UN Regulation No. 107 (M₂ and M₃ vehicles)

Proposal for Supplement 5 to the 07 series of amendments and Supplement 4 to the 08 series of amendments to UN Regulation No. 107

**Submitted by the expert from the Informal Working Group on the
behaviour of the general construction of M₂ and M₃ vehicles in a fire
event ***

**"Figure 32
Patterns for cutting plastic film on emergency window or escape hatch**

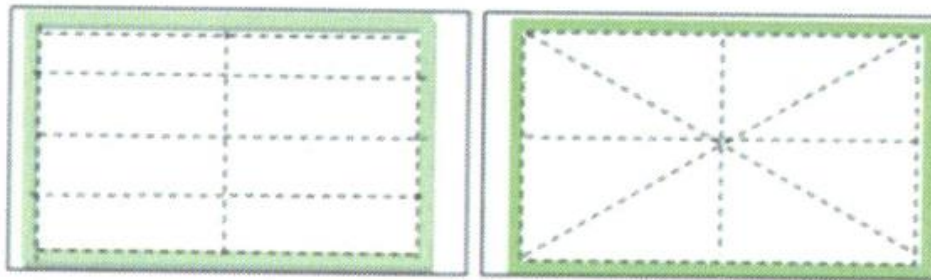
- 7.6.8.2.2.4. The inner surface of each emergency window may be fitted with a plastic film to enable the person to remove the window pane or panes with his hands. The plastic film shall be cut at the outer edge of the emergency window and following the patterns as shown in Annex 4, Figure 32. In case of fitting a plastic film to the emergency exit, it shall be compatible with the device for breaking the glass and shall not reduce its efficiency. In addition, the characteristics of the approved glazing shall remain unchanged. ~~The device for breaking the glass for the emergency windows at the rear of the vehicle shall be positioned either centrally above or below the emergency window or, alternatively, a device shall be positioned adjacent to each end of the window."~~**

- 7.6.9.5.3. **The inner surface of each escape hatch may be fitted with a plastic film to enable the person to remove the window pane or panes with his hands. The plastic film shall be cut at the outer edge of the escape hatch and following the patterns as shown in Annex 4, Figure 32. In case of fitting a plastic film to the escape hatch, it shall be compatible with the device for breaking the glass and shall not reduce its efficiency. In addition, the characteristics of the approved glazing shall remain unchanged."**
